SUBMITTAL OF HANFORD FACILITY RESOURCE CONSERVATION AND RECOVERY
ACT (RCRA) PERMIT MODIFICATION NOTIFICATION FORM 24590-LAW-PCN-ENV-
06-014

Modification Notification Form 24590-LAW-PCN-ENV-06-014 updates the process flow
diagram for Low-Activity Waste Vitrification Secondary Offgas Treatment (24590-LAW-M5-
V17T-P0011) in Appendix 9.1 of the Reference.

Hanford Facility RCRA Permit Modification Notification
Form 24590-LAW-PCN-ENV-06-014

Page 2 of 3: Hanford Facility RCRA Permit, Operating Unit 10, Waste Treatment and Immobilization Plant
Update LAW Vitrification Building Process Flow Diagram (PFD) for LAW Vit Secondary Offgas Treatment
(24590-LAW-M5-V17T-P0011) in Appendix 9.1 of the Dangerous Waste Permit.

24590-LAW-M5-V17T-P0011

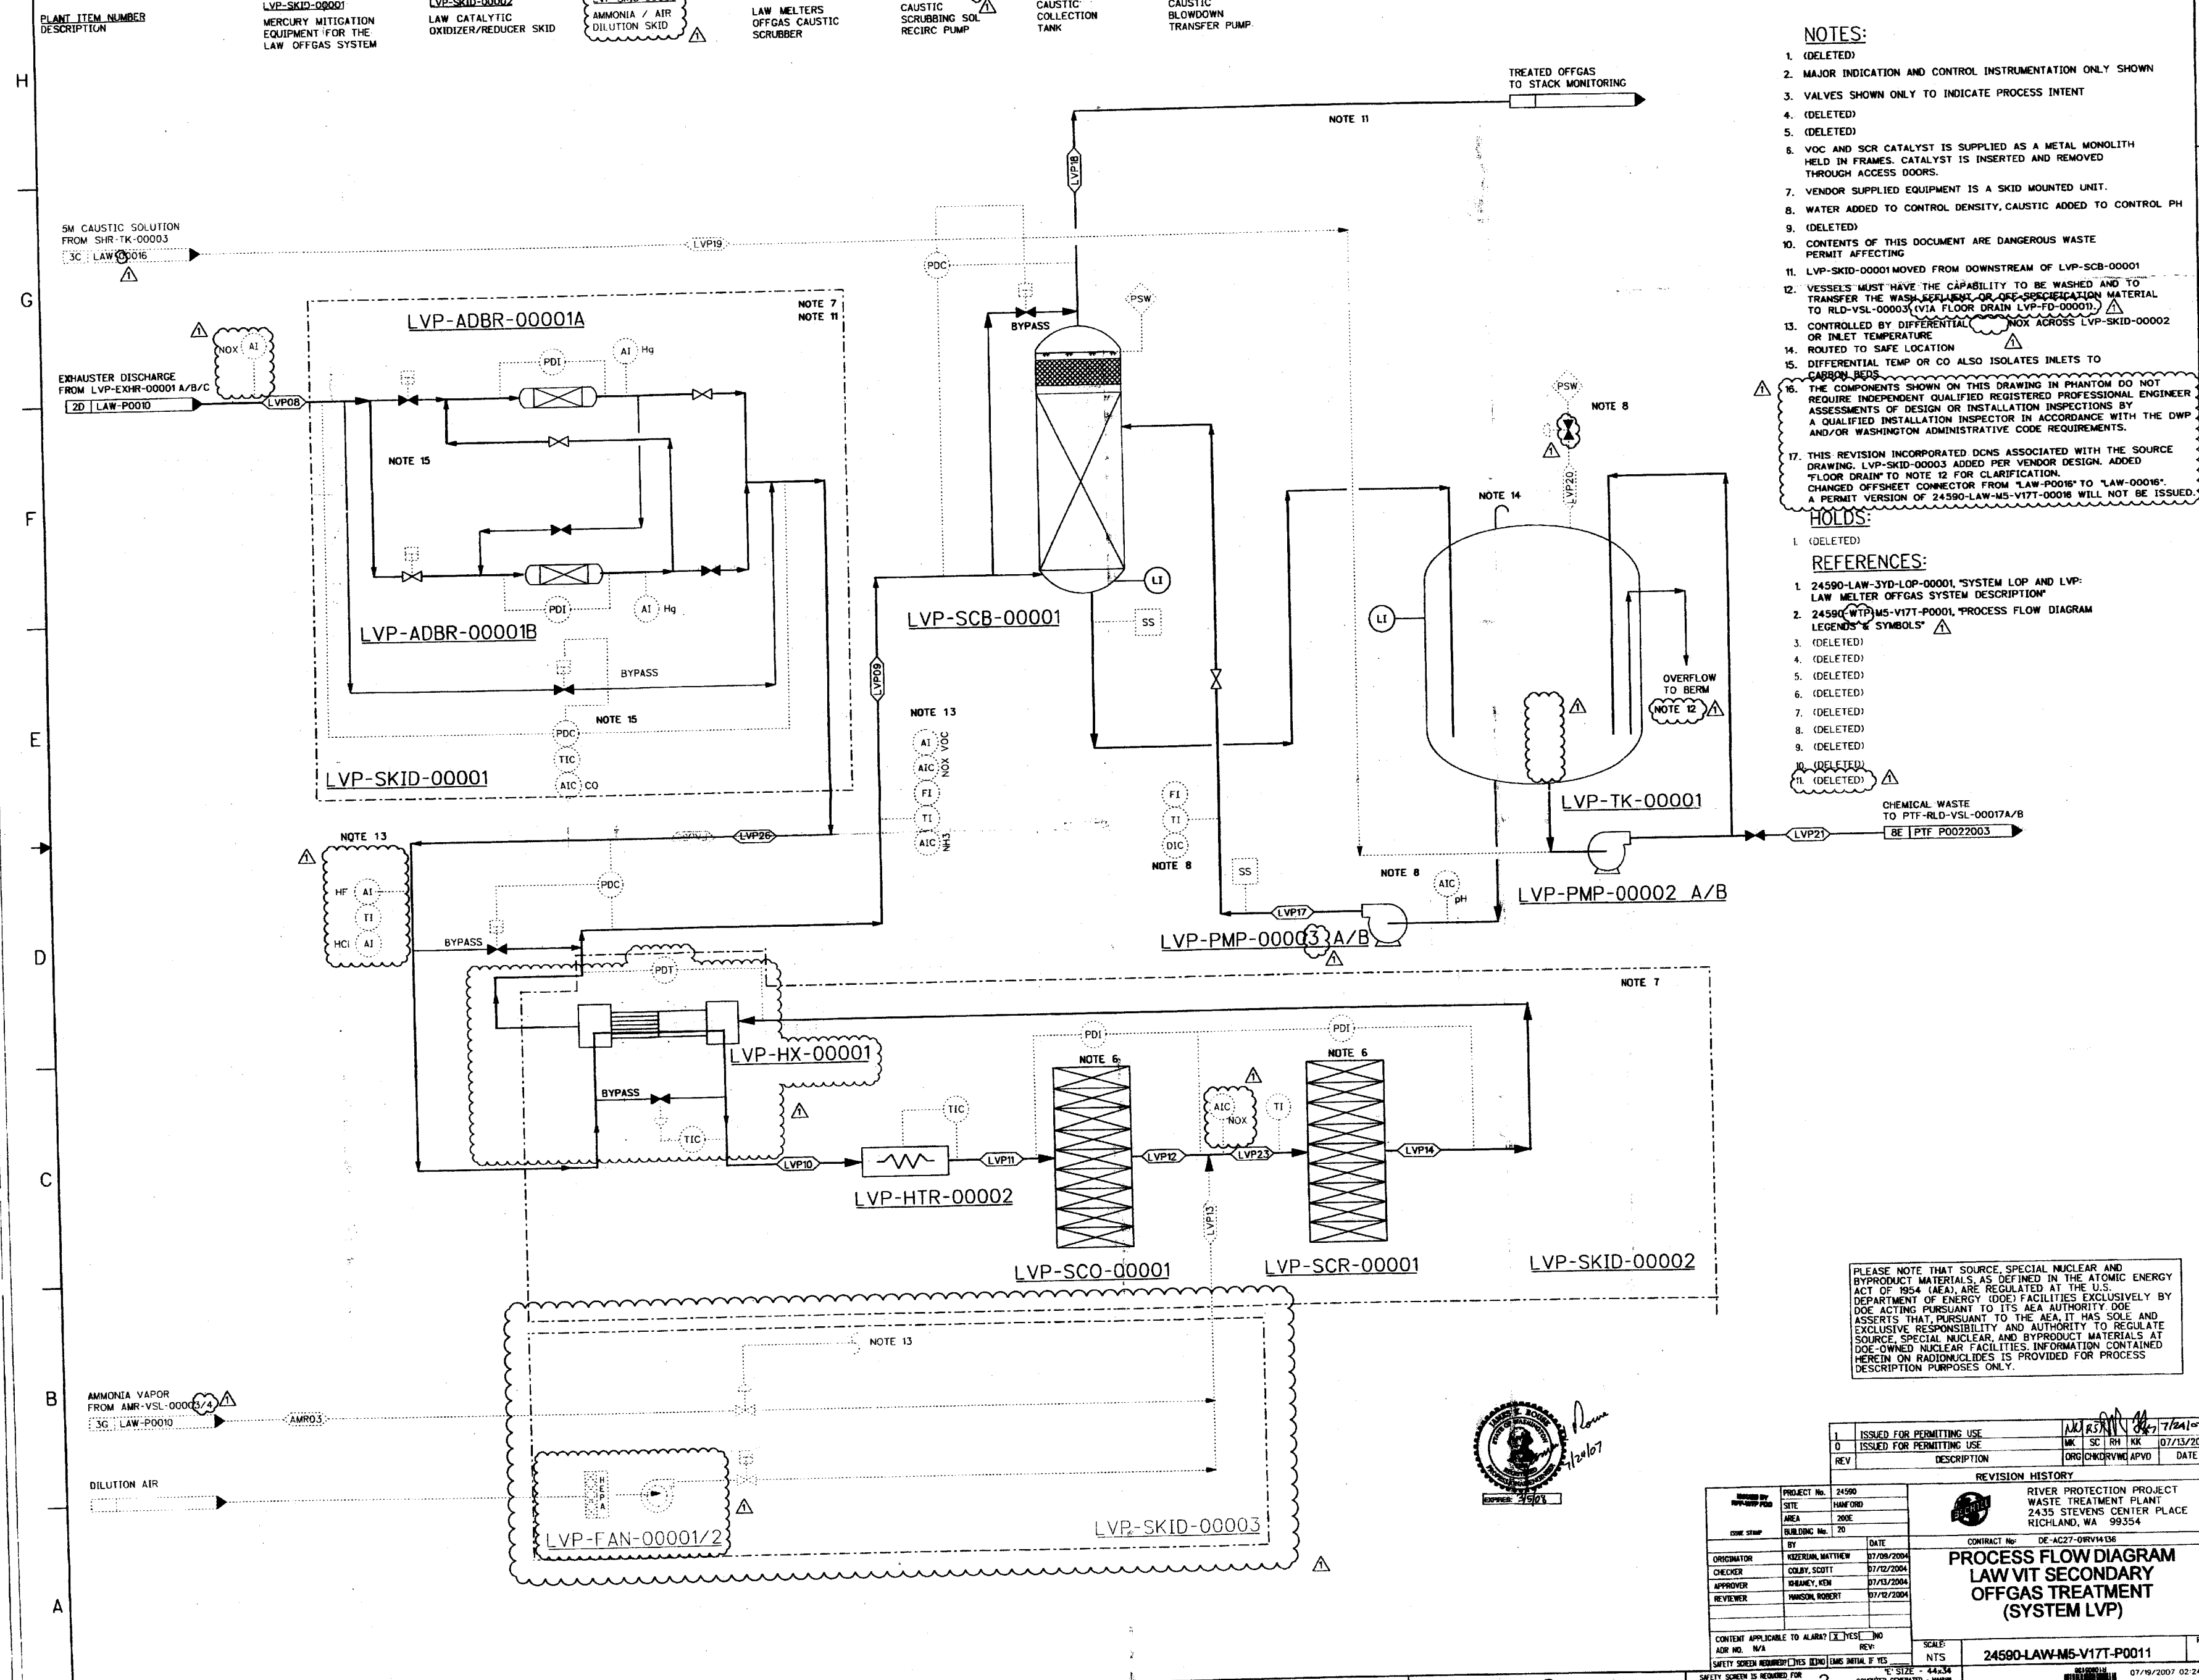
Hanford Facility RCRA Permit Modification Notification Form	
Unit:	Permit Part & Chapter:
Waste Treatment and Immobilization Plant	Part III, Operating Unit 10
<p><u>Description of Modification:</u></p> <p>The purpose of the modification is to update a LAW process flow diagram (PFD) for the LAW vitrification secondary offgas treatment system, identified as 24590-LAW-M5-V17T-P0011, Rev. 0, located in Appendix 9.1 of the Dangerous Waste Permit (DWP).</p> <p>Ecology is requested to approve the following changes to the subject PFD:</p> <ol style="list-style-type: none"> Note 12 is changed from: "Vessels must have the capability to be washed and to transfer the wash effluent or off-specification material to RLD-VSL-00003." To: "Vessels must have the capability to be washed and to transfer the wash effluent or off-specification material to RLD-VSL-00003 (via floor drain LVP-FD-00001)." Note 13 revised from: "Controlled by differential NH3 and NOX across LVP-SKID-00002 or inlet temperature." To: "Controlled by differential NOX across LVP-SKID-00002 or inlet temperature." Added Note 17 "This revision incorporated DCNs associated with the source drawing. LVP-SKID-00003 added per vendor design. Added "floor drain" to Note 12 for clarification. Changed offsheet connector from "LAW-P0016" to "LAW-00016". A permit version of 24590-LAW-M5-V17T-00016 will not be issued." Corrected document number in Reference 2. Revise from: "24590-PTF-M5-V17T-P0001, "Process Flow Diagram Legends & Symbols" To: "24590-WTP-M5-V17T-P0001, "Process Flow Diagram Legends & Symbols" Added Reference "11. (Deleted)", as Reference 11 was added to the source drawing, but is not applicable to the permit version. Revised the valve for plant service water additions to LVP-TK-00001 from being normally open to being normally closed. The portion of the transfer line shown in LVP-TK-00001, which goes to LVP-PMP-00002 A/B, was shown incorrectly and is being deleted. This does not affect the design of the system. A reference to Note 12 is being added to the "Overflow to Berm" for LVP-TK-00001. The plant item number for LVP-PMP-00001 A/B is changing to "LVP-PMP-00003 A/B" as a result of a pump flowrate change from 60 gpm to 200 gpm per vendor recommendation. Revised non-permit affecting offsheet connector label for the 5M caustic solution from SHR-TK-00003 from: "LAW-P0016" to "LAW-00016". A permit version of the source will not be issued as the source drawing contains only systems associated with cold chemical product. Revised non-permit affecting offsheet connector label from "Ammonia Vapor from AMR-VSL-00001/2" to "Ammonia Vapor from AMR-VSL-00003/4." The vessels are renumbered because they are being transferred to BOF. Added a NOx indicator to waste stream LVP08 prior to entry into LVP-SKID-00001. Revised the instrumentation on waste stream LVP26 prior to entering LVP-SKID-00002 Revised from the following indicators: NOx, VOC, temperature, and NH3. To indicators for the following: HF, temperature, and HCL. The NOx indicator is being moved to the carbon adsorber inlet as identified in Change #12. The VOC and NH3 indicators are being replaced with HF and HCL indicators to reflect the vendor design. Added a NOx indicator to waste stream LVP23 prior to the temperature indicator in LVP-SKID-00002. The plant item number for LVP-BLWR-00001 A/B is being corrected to "LVP-FAN-00001/2"

consistent with the tag names in the vendor package.

16. LVP-FAN-00001/2 and associated air piping along with ammonia vapor from AMR-VSL-00003/4 is being split from LVP-SKID-00002 and is now its own (new) skid, LVP-SKID-00003. LVP-SKID-00003 is also added to the plant item number and descriptions at the top of the drawing.

17. Added a HEPA filter to LVP-SKID-00003 dilution air prior to LVP-FAN-00001/2 to depict the vendor design.
18. The bypass associated with LVP-HX-00001 has been reconfigured to indicate the vendor design.

19. The symbol for LVP-FAN-00001/2 is corrected from a centrifugal pump symbol to a fan symbol.
20. Bolded notes and reworded Note 16 to read: "The components shown on this drawing in phantom do not require Independent Qualified Registered Professional Engineer assessments of design or installation inspections by a qualified installation inspector in accordance with the DWP and/or Washington Administrative Code requirements."

- THIS REVISION INCORPORATED DCNS ASSOCIATED WITH THE SOURCE DRAWING. LVP-SKID-00003 ADDED PER VENDOR DESIGN. ADDED "FLOOR DRAIN" TO NOTE 12 FOR CLARIFICATION. CHANGED OFFSHEET CONNECTOR FROM "LAW-P0016" TO "LAW-00016". A PERMIT VERSION OF 24590-LAW-M5-V17T-P0011 WILL NOT BE ISSUED.

Appendix 9.1			
Replace:	24590-LAW-M5-V17T-P0011, Rev. 0	With:	24590-LAW-M5-V17T-P0011, Rev. 1
